COMMUNITY DEVELOPMENT DEPARTMENT

SUBJECT: H-2022-0047
Bridgetower Multi-family CUP

Request for Conditional Use Permit (CUP) for a multi-family development consisting of 235 units on 16.61 acres of land in the R-15 zoning district, by Alpha Development Group.

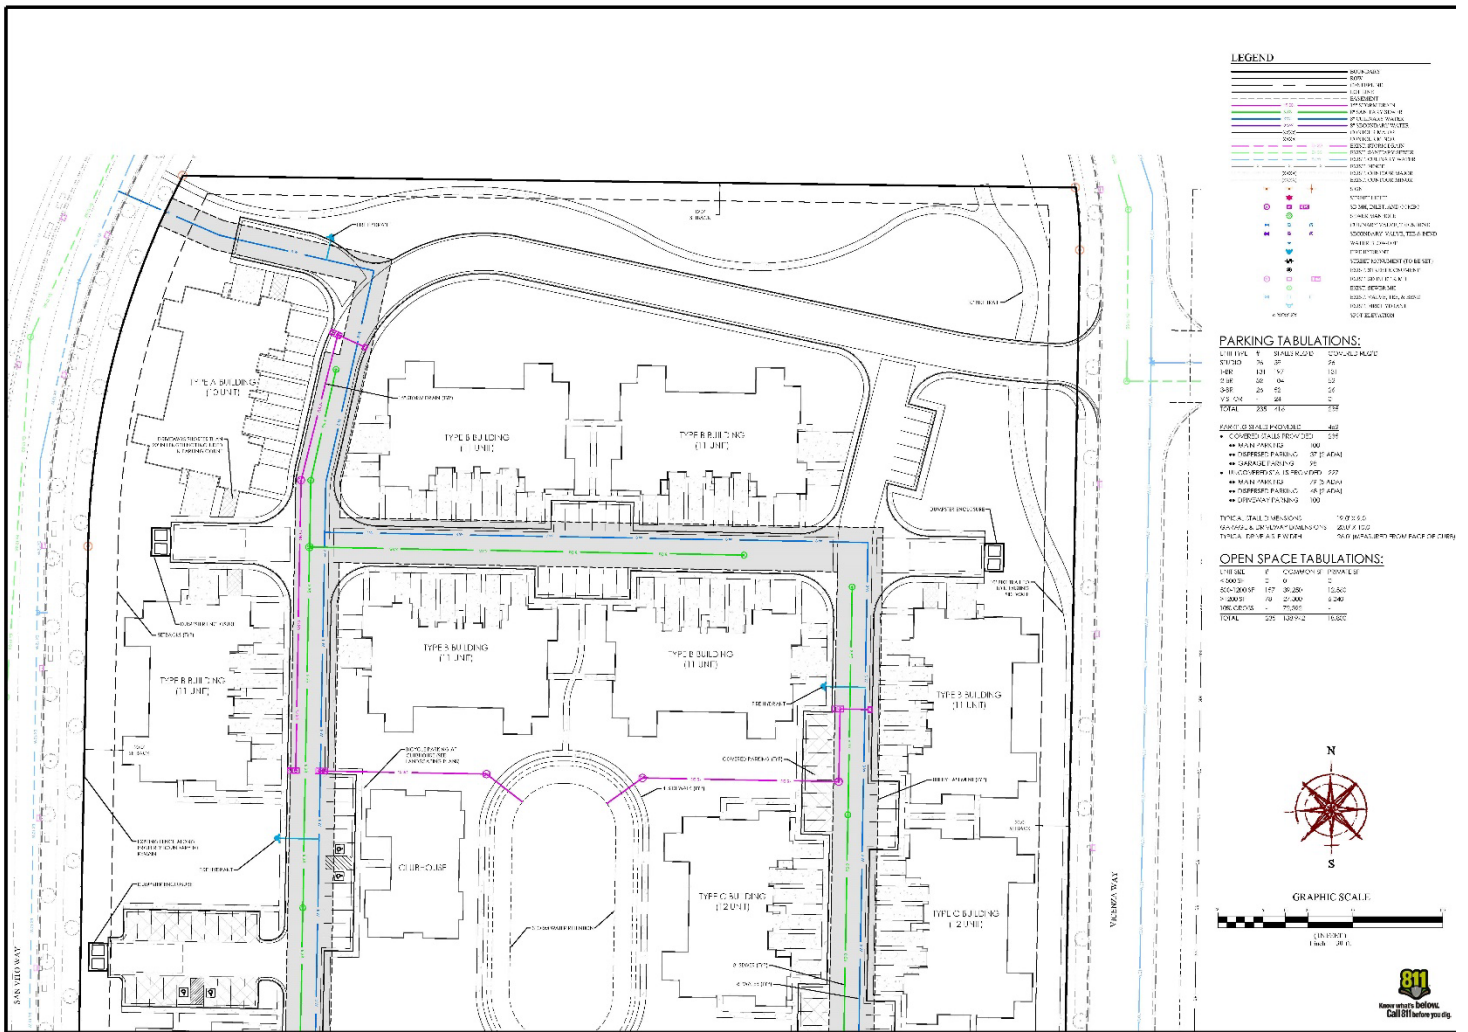
Staff has analyzed the submitted building elevations against the Architectural Standards Manual and finds the submitted elevations to be generally compliant. Staff is recommending specific revisions to be submitted with the future CZC application showing compliance with the following standards:

1. *R1.2A, 3.2D, & 5.2A – add additional color combinations or materials;*
2. *R3.4A – extend the roof overhangs or apply for a Design Standard Exception;*
3. *R5.2D – Comply; add qualifying masonry material along the base of the multi-plex buildings;*

- d. Add the required trees adjacent to the new multi-use pathway segment along the north boundary per UDC 11-3B-12.
- 4. With the future CZC application, revise the multi-plex elevations to reflect compliance with the required Architectural Standards per the analysis in the Building Elevations section above in Section V:

- a. Add additional color combinations and materials to comply with R1.2A, 3.2D, & 5.2A;
 - b. Extend the roof overhangs or apply for a Design Standard Exception to comply with R3.4A;

- c. Add qualifying masonry material along the base of the multi-plex buildings to comply with R5.2D.
- 5. The Applicant shall submit a revised open space exhibit with the future CZC application that reflects the most up to date site plan, landscape plan, and any staff recommended revisions for the development.

A. Site Plan (NOT APPROVED)

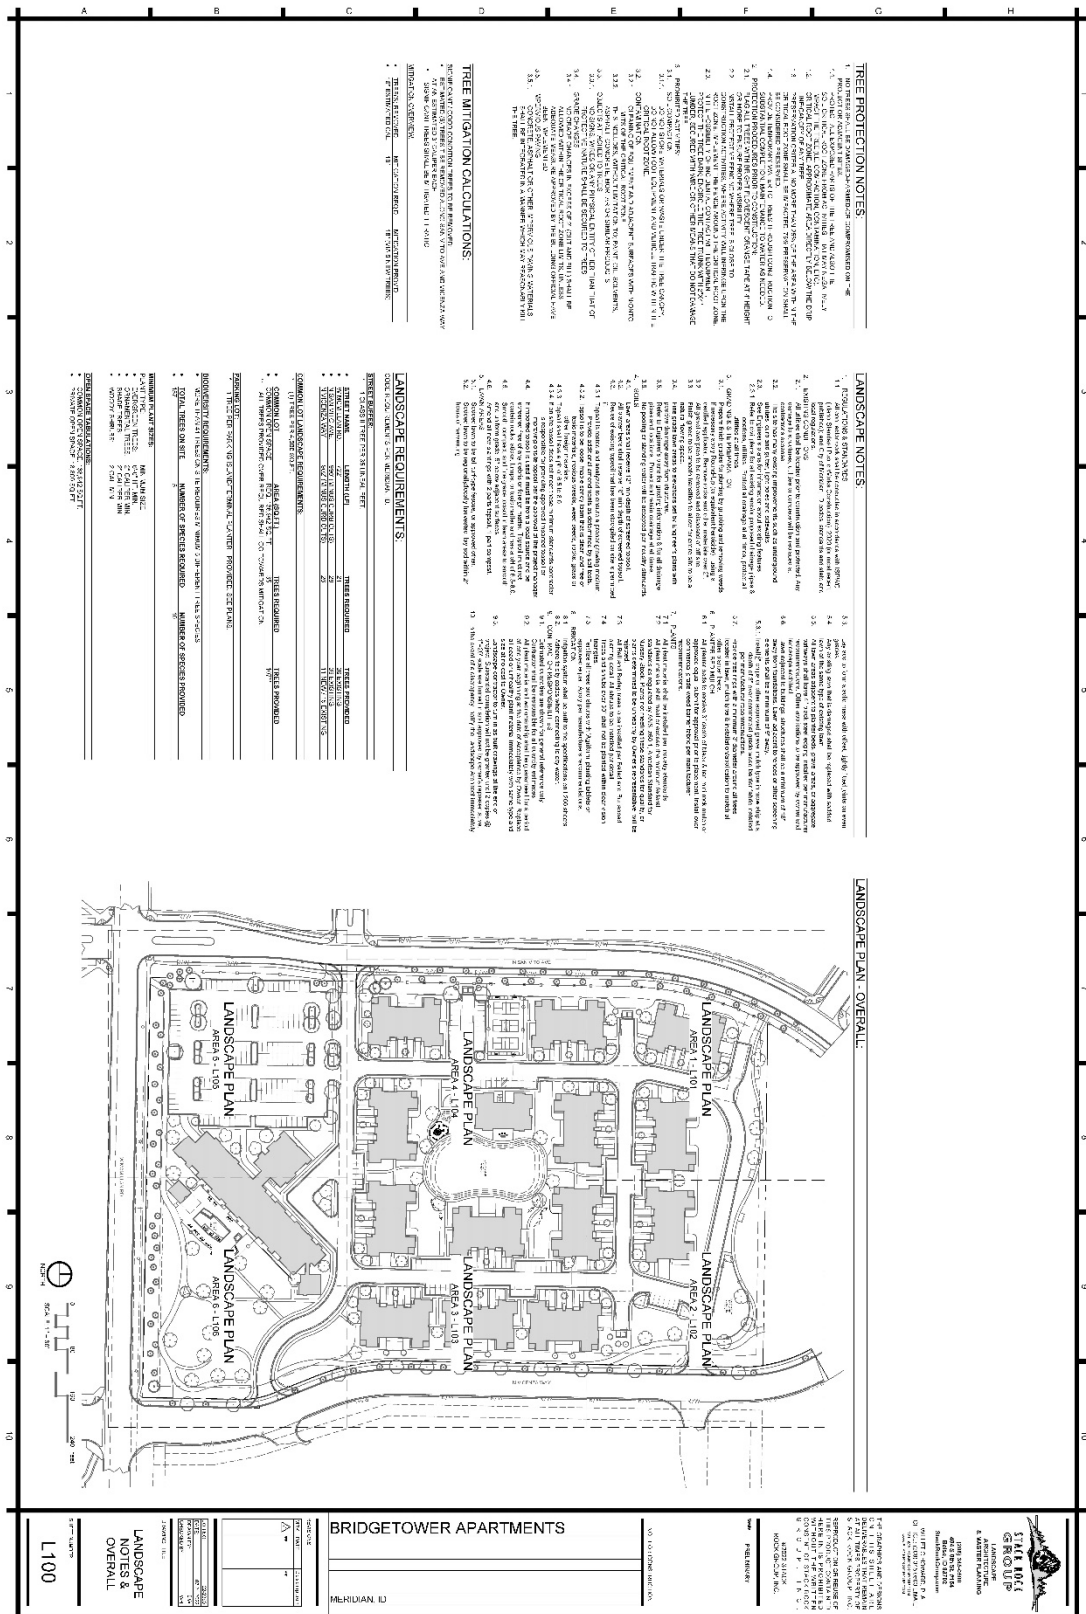
The Applicant is proposing more than 20 units (235 units) so the Applicant is required to provide the items above in compliance with this standard. The submitted Site Plan does not depict a maintenance storage area but all other requirements are depicted. The Applicant should revise the site plan to show the maintenance storage area with the future CZC application.

As noted above, it appears the internal sidewalks are 4 feet wide instead of 5 feet wide. Staff is recommending all of these are revised and shown as 5-feet wide with the future CZC application. In addition, the submitted plans depict the required multi-use pathway along the east boundary but not along the north boundary nor shows a connection to the existing detached sidewalk along McMillan, as required by Parks. The Applicant should revise all plans to show this 5-foot sidewalk as 10-foot and add a connection to the McMillan sidewalk with the future CZC application.

The drive aisle near the south end of the site connecting San Vito Way to Vicenza Way separates the townhome style product from the 3-story internally accessed apartment building. Staff has noted to the Applicant that some form of traffic calming should occur along this drive aisle to help with pedestrian safety; as currently proposed, Staff believe this drive aisle to be an unsafe area for residents to cross to access the amenities and open space located in the center of the development or the arterial sidewalk along McMillan.

For this reason, Staff is recommending revisions to this area of the site plan to help make this area safer:

- 1. Rotate the two center buildings that take access from this drive aisle 90 degrees to have their driveway accesses to the east and west instead;*
- 2. Relocate the 7 off-street parking stalls in this area to remove back-out parking altogether;*
- 3. Show at least two bulb-outs on this drive aisle to help choke this drive aisle for traffic calming with one of them being located where the north-south pedestrian facility is shown from the center of the site to the stacked building;*
 - a. Make this crossing with different material per UDC 11-3A-19B.4 (i.e. brick, pavers, stamped/colored concrete) and with a table-top speed bump consistent with Fire department standards.*

4. *Staff would prefer the west north-south drive aisle align with one of the drive aisle entrances for the parking lot in the southwest corner of the property.*

2. With the future CZC application, the site plan included in Section VII.A, shall be revised as follows:
 - a. Show all sidewalks as a minimum 5 feet wide except for those required to be multi-use pathways;

- b. Depict a 10-foot wide multi-use pathway along the north and east boundaries that connect to the San Vito and Gondola intersection and to the existing arterial sidewalk along McMillan road near the southeast corner of the site; the sidewalk along the south boundary currently shown as 10 feet may be reduced to 5 feet per this condition.

- c. Show any pedestrian facility that crosses a drive aisle to be constructed in accord with UDC 11-3A-19B.4 (i.e. brick, pavers, stamped/colored concrete).

- d. Show the required maintenance storage area per the specific use standards (UDC 11-4-3-27).
 - e. Rotate the two south-center buildings that take access from the southern drive aisle 90 degrees to have their driveway accesses to the east and west instead.

- f. Relocate the 7 off-street parking stalls along the southern drive aisle to remove back-out parking in this area.
 - g. Show at least two bulb-outs on the south east-west drive aisle to help choke down this drive aisle for traffic calming with one of them being located where the north-south pedestrian facility is shown from the central open space area to the stacked "T" building.

- h. Realign the west north-south drive aisle with one of the drive aisle entrances for the parking lot in the southwest corner of the property.
 - i. Add an additional driveway connection to N. San Vito Way in alignment with W. Gondola Drive across the southwest corner of the adjacent property (S0427417210) and extend the sidewalk to this intersection in accord with UDC 11-3A-3 and UDC 11-3B-9C.3. If this connection cannot be constructed at this time, Applicant may stub driveway connection to shared property line and provide a cross-access ingress/egress easement at its location for future connectivity.

B. Landscape Plan

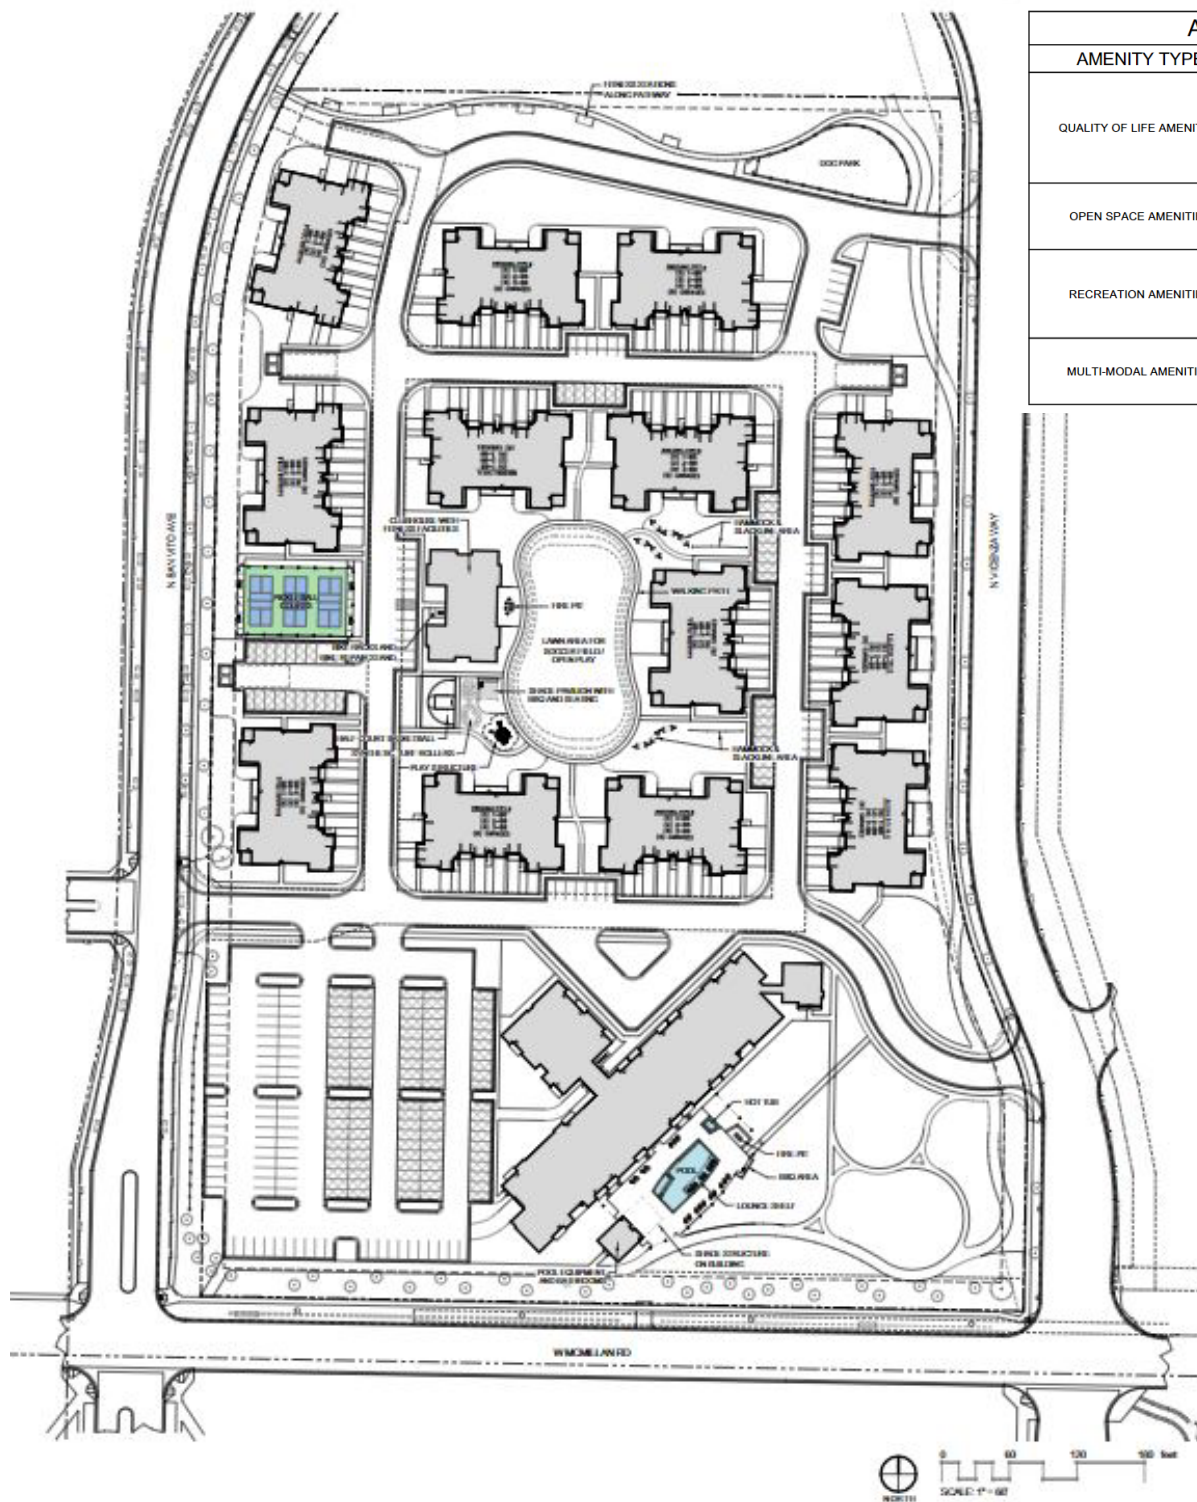
According to the submitted landscape plans, all required landscaping appears to be shown except for additional trees along the multi-use pathway segment that should be along the north boundary (required to be shown on future plans). The Applicant should add the required trees adjacent to this pathway along the north boundary when the plans are revised to include this additional pathway segment.

No new fencing is shown in the legend of the landscape plans but new fencing is depicted near the northeast corner of the site for the proposed dog park. The Applicant should correct the plans to depict the type of fencing proposed for the dog park area and to ensure compliance with UDC 11-3A-7. Any existing fencing is noted to be protected and remain on the site.

3. With the future CZC application, the landscape plan included in Section VII.B shall be revised as follows:
 - a. Revise the plans to reflect Staff's recommended changes above.

- b. Add any proposed fencing to the Landscape Plan legend (i.e. fencing proposed for the fenced dog park).

- c. Depict the required street buffers along San Vito Way, Vicenza Way, and McMillan Road regardless of ownership status to ensure compliance with UDC dimensional standards in UDC Table 11-2A-7 and to be landscaped per UDC 11-3B-7.
